Yorkshire Green Energy Enablement (GREEN) Project

**Document 8.37 Applicant's Response to the ExA's 8th September
2023 Rule 17 Request for Further Information**

Planning Inspectorate Reference: EN020024

NATIONAL GRID (YORKSHIRE GREEN ENERGY ENABLEMENT PROJECT)
 ILLUSTRATIVE PLAN: A659 ACCESS - TADCASTER
 REGULATION 5(2)(o)
 SHEET 2 OF 2

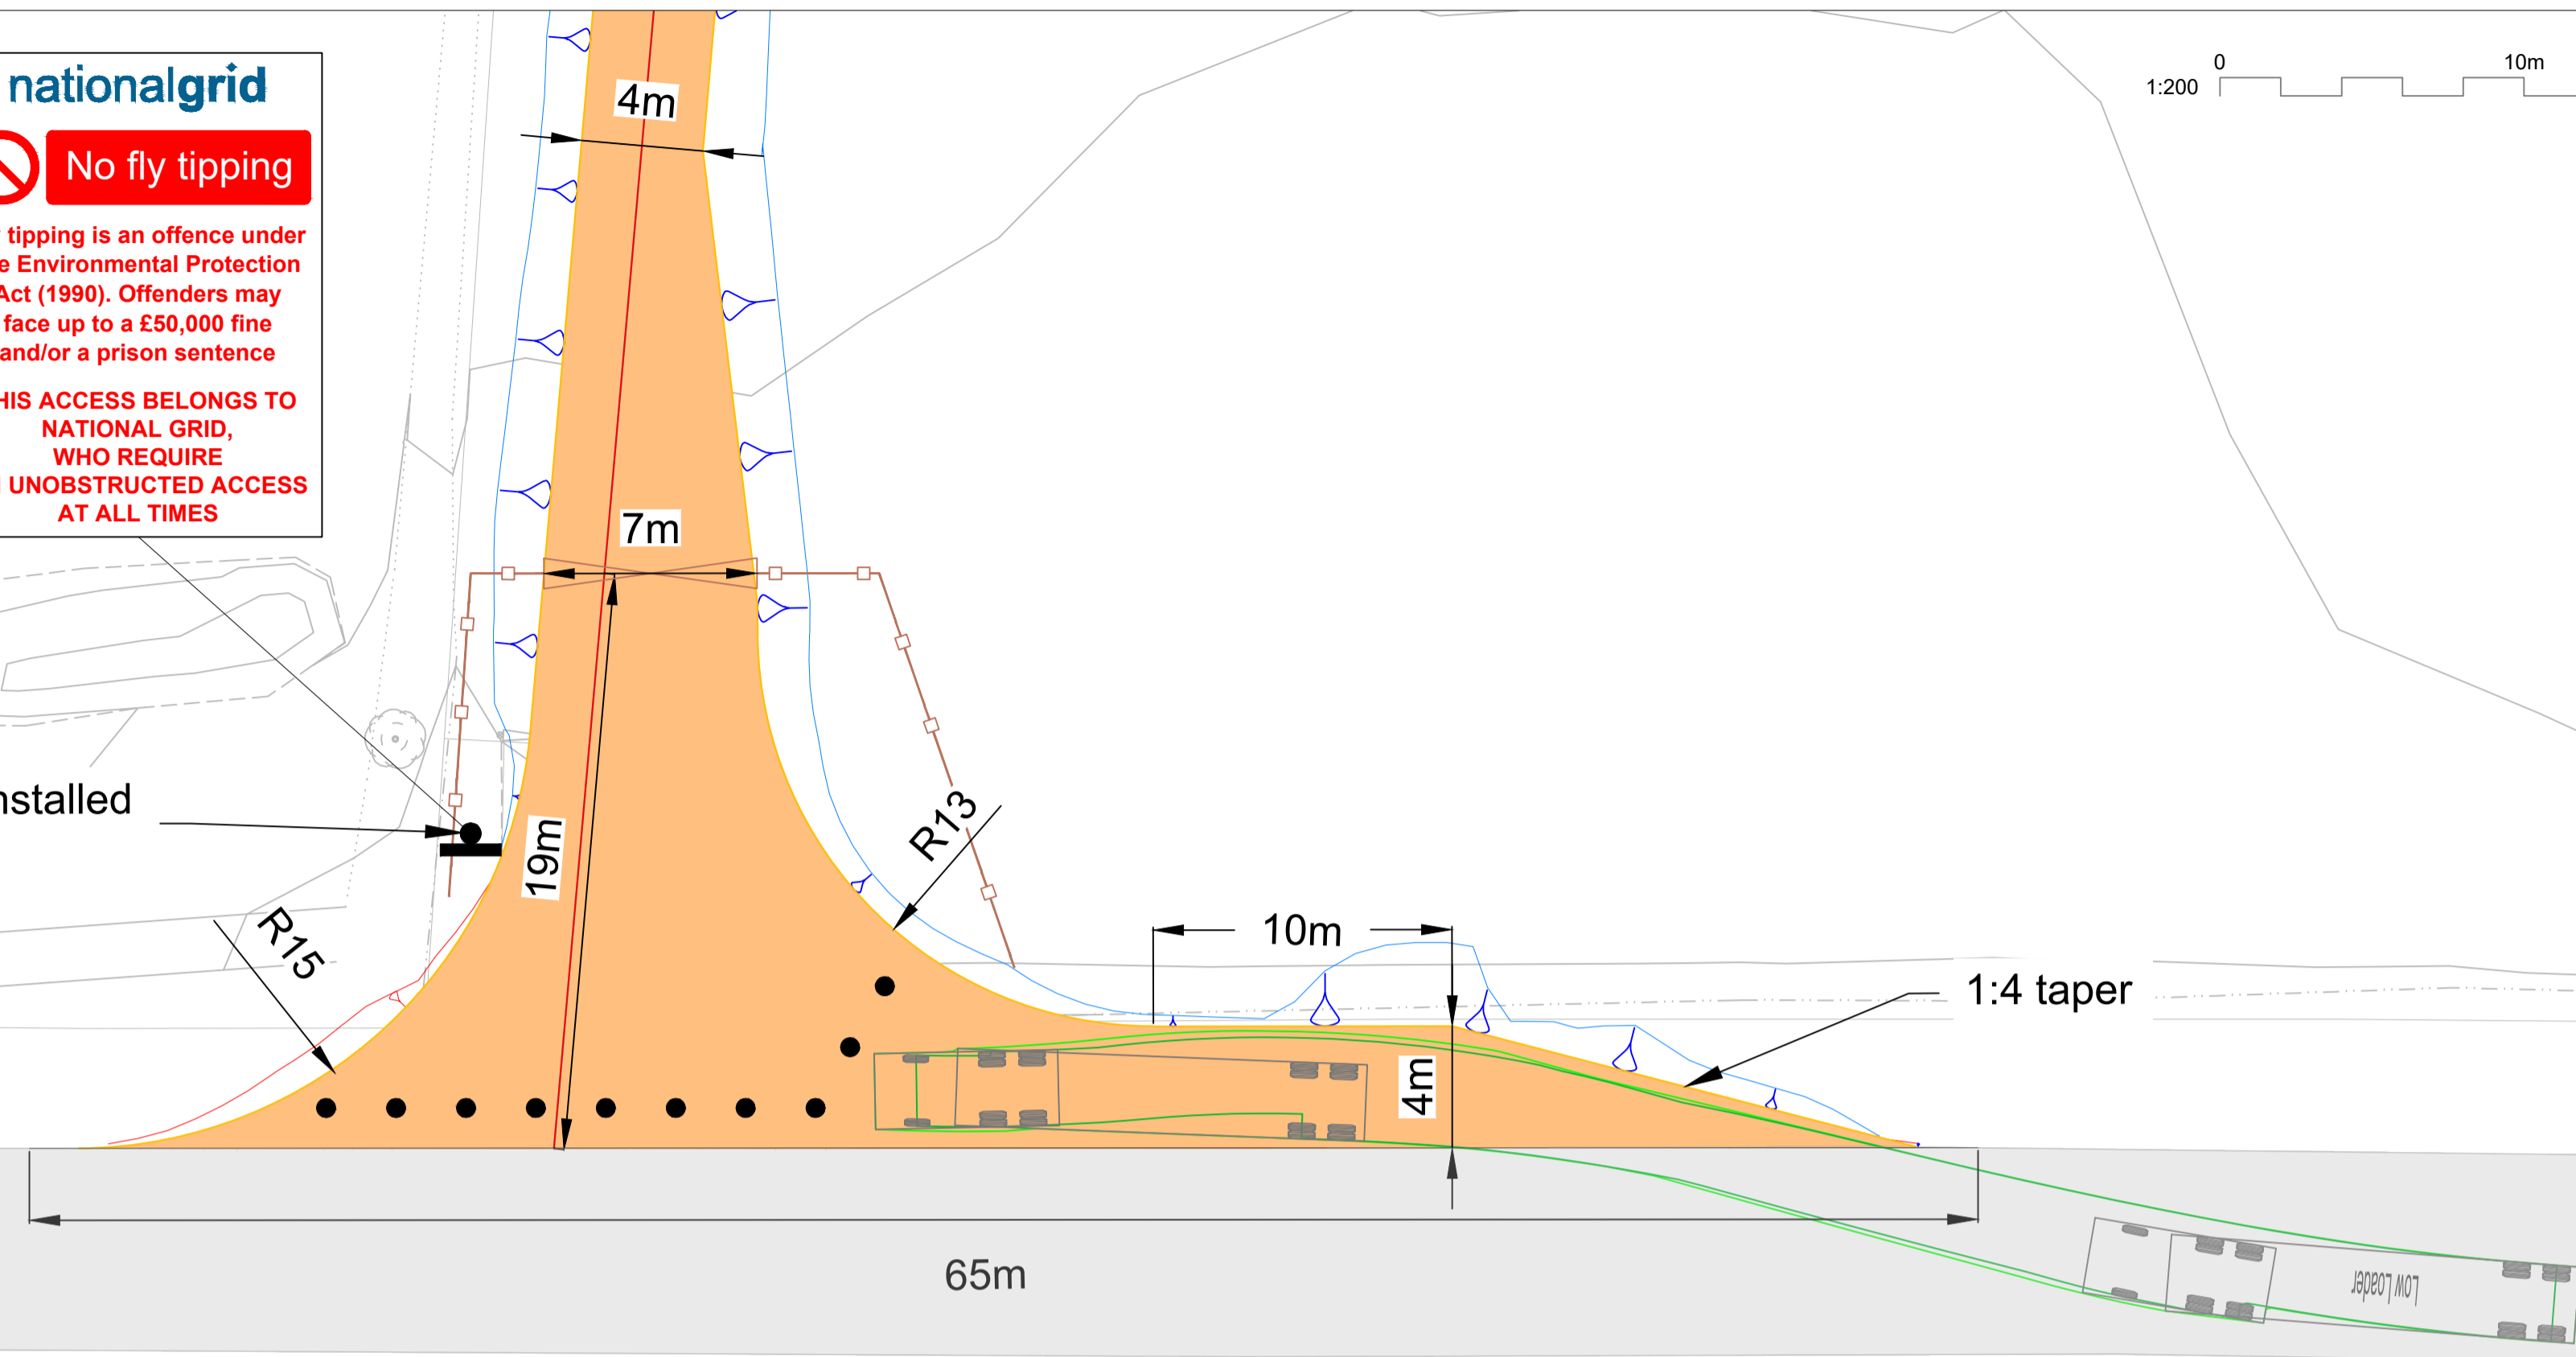
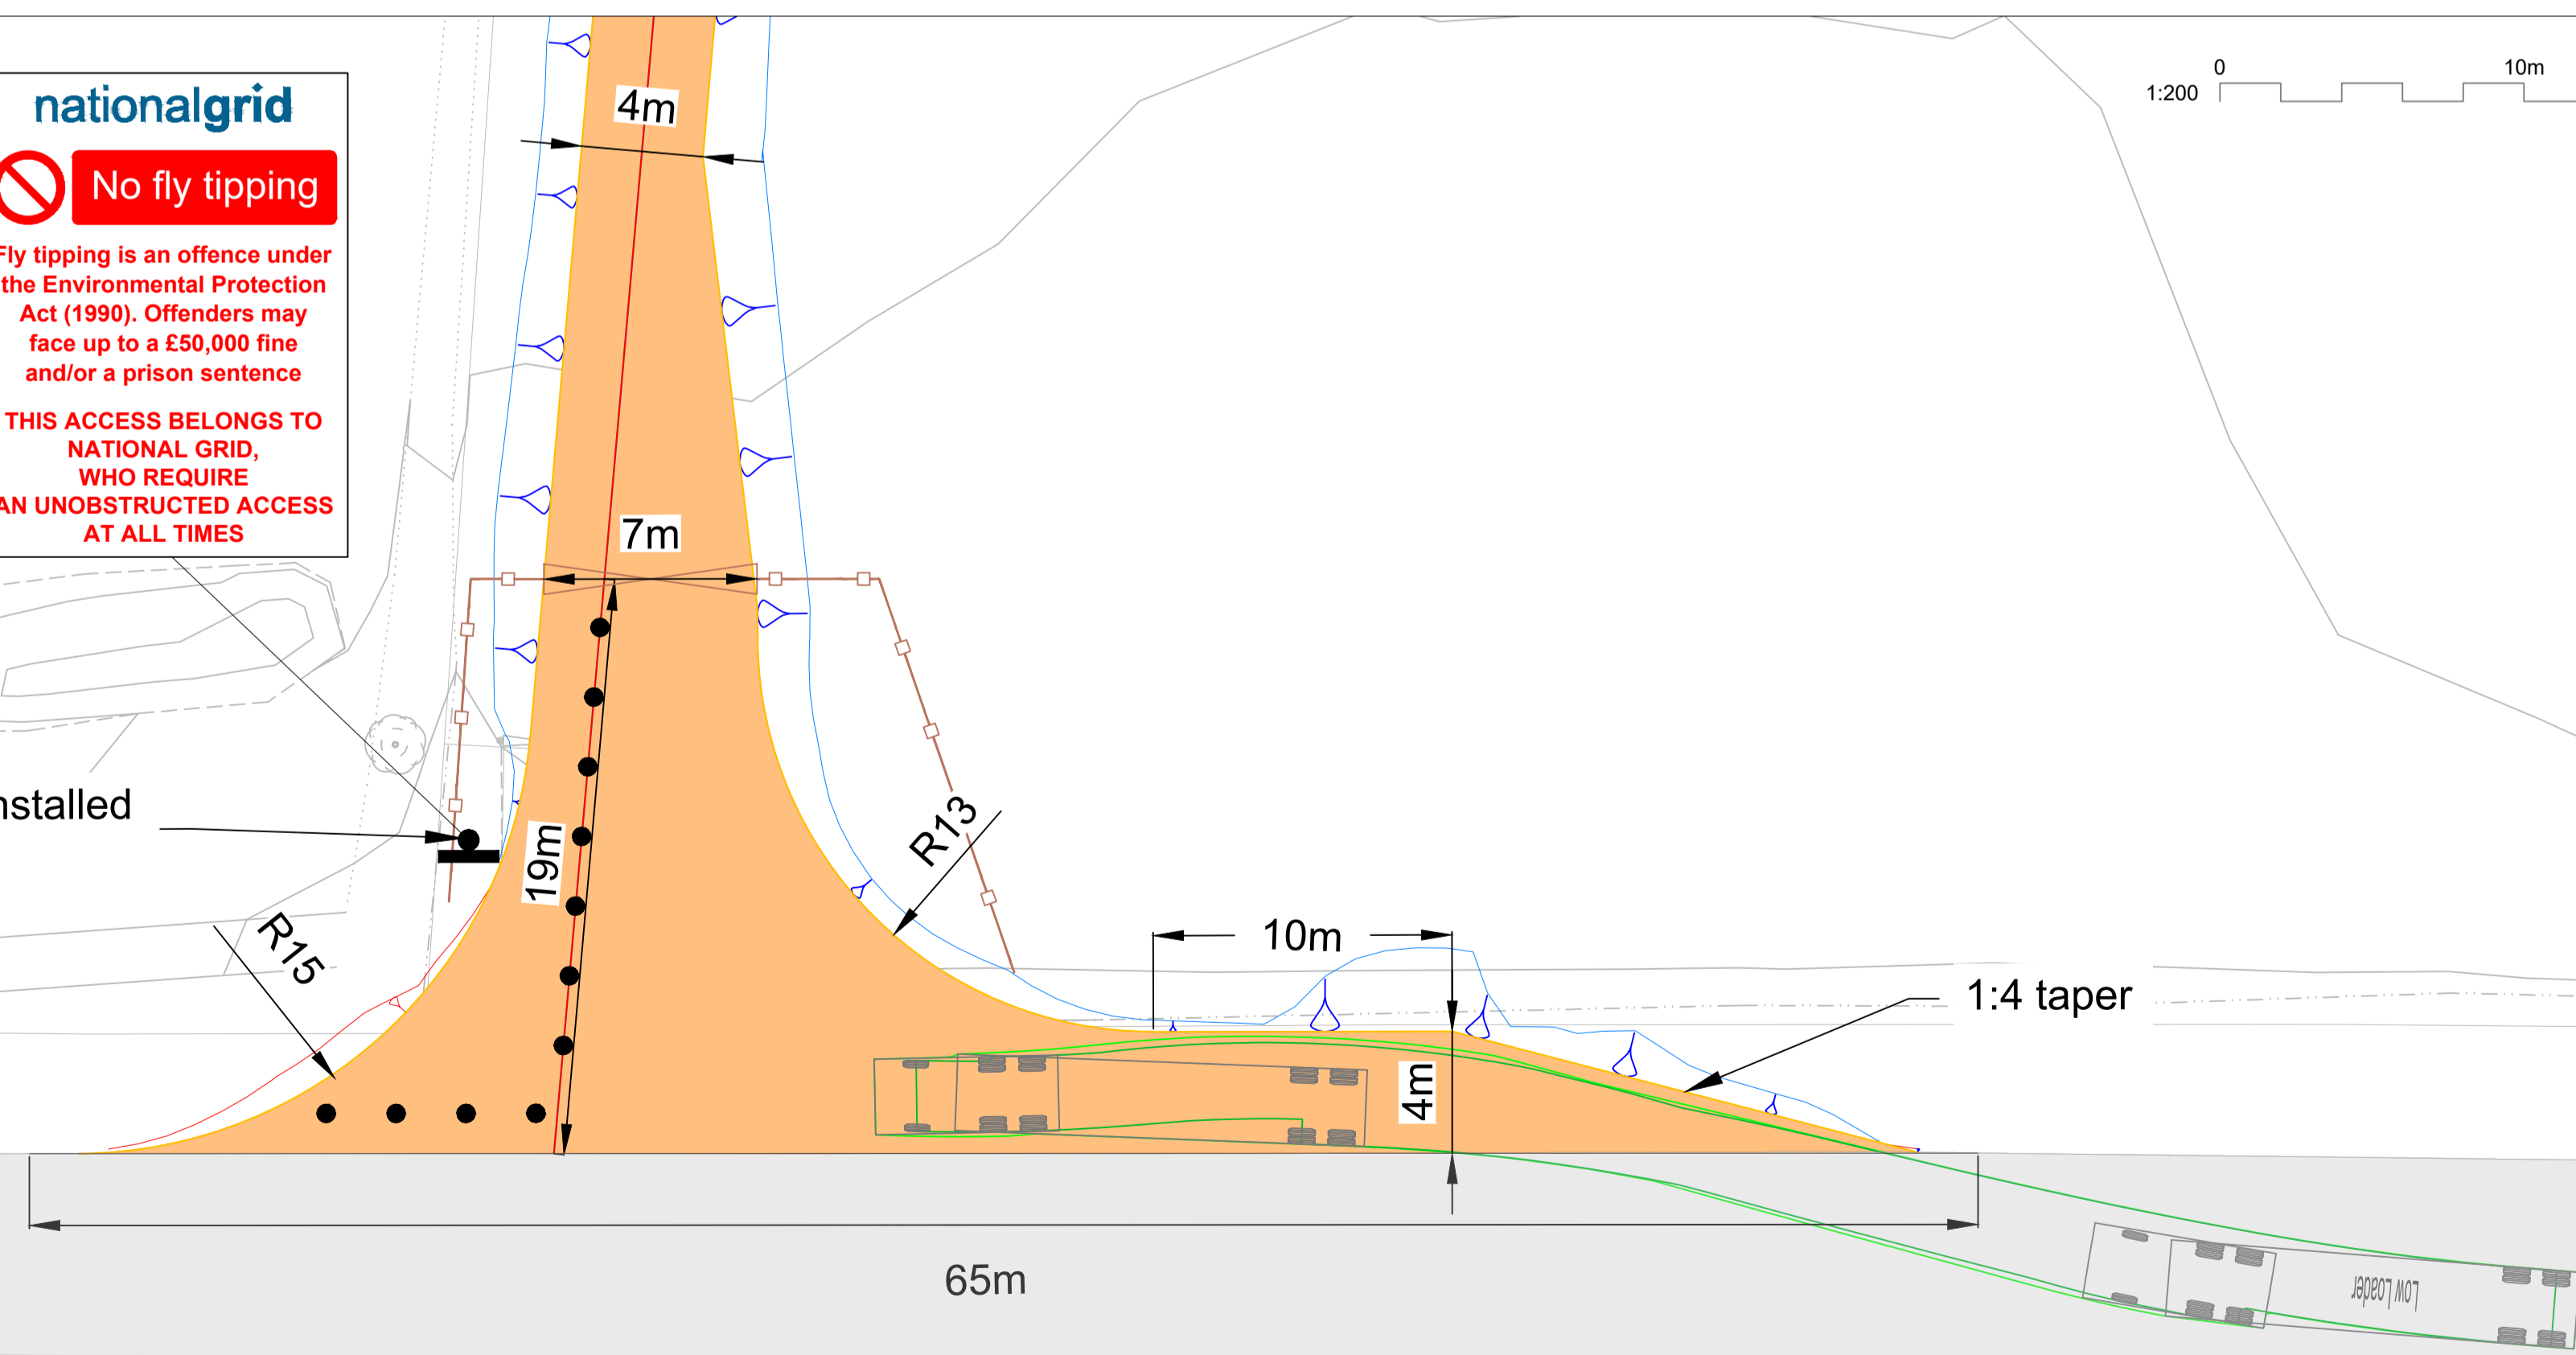
<ul style="list-style-type: none"> • Explain why a track of 7 metres width is shown on the illustrative plan; • If it remains the Applicant’s position that a track with a width of 4 metres could be accommodated, submit a version of the illustrative plan that shows this; and • For the avoidance of doubt, confirm whether the reference to the A361 in the title of Appendix A should instead be to the A659. 	<p>landowner to the Examination, this illustrative plan was also submitted to the Examination in the document referenced above.</p> <p>An access track 7m wide was shown on the illustrative plan as this is the width of the access track included in the application. However as noted above, National Grid considers that a 4m access track could be accommodated but National Grid would require flexibility within the 7m corridor for detailed design of siting and space for drainage of the permanent access. Therefore, National Grid considered it suitable for the illustrative plan to be provided based on the worst case scenario.</p> <ul style="list-style-type: none"> • <u>If it remains the Applicant’s position that a track with a width of 4 metres could be accommodated, submit a version of the illustrative plan that shows this.</u> <p>National Grid has prepared a further Illustrative Plan provided in Appendix B to this document, to provide a representation of what the options may look like based on a 4m wide access. However, this is based on the same dimensions of the bellmouth as shown on the 7m wide access arrangement with the permanent access tapering off to 4m beyond the gate as these remain illustrations prior to detailed design.</p> <p>As detailed above because flexibility is required for siting and space for drainage, this plan is only an illustration and does not represent the exact location of where the access would be located within the Order limits. National Grid has not been able to engage with the landowner on this matter as they have been unavailable for a meeting and no reply was received to National Grid’s emails of 16 August and 5 September 2023 providing the illustrative plan. Therefore National Grid has not been able to progress the development of a potential solution further with the landowner. National Grid will continue to seek to engage Mr Watson and his agent further on the details of the detailed design of the permanent bellmouth and permanent access arrangement should</p>

<p>consent be obtained as it is in National Grid’s interest to reach a solution that works for both parties to secure the access from fly tipping.</p> <ul style="list-style-type: none">• <u>For the avoidance of doubt, confirm whether the reference to the A361 in the title of Appendix A should instead be to the A659.</u> <p>Yes, that is correct the reference in the title should be to the A659 and not the A361. This has been corrected for the 4m access version of the illustrative plan submitted at Appendix B. National Grid has also updated the illustrative plan provided in response to Action 6 at Appendix A of the Applicant’s Deadline 7 Response to CAH2 Hearing Action Points (Document 8.29.5) [REP7-046] submitted at Deadline 7 and this is provided at Appendix C of this document. In doing so National Grid has also corrected a typographical error.</p>
--	--	--
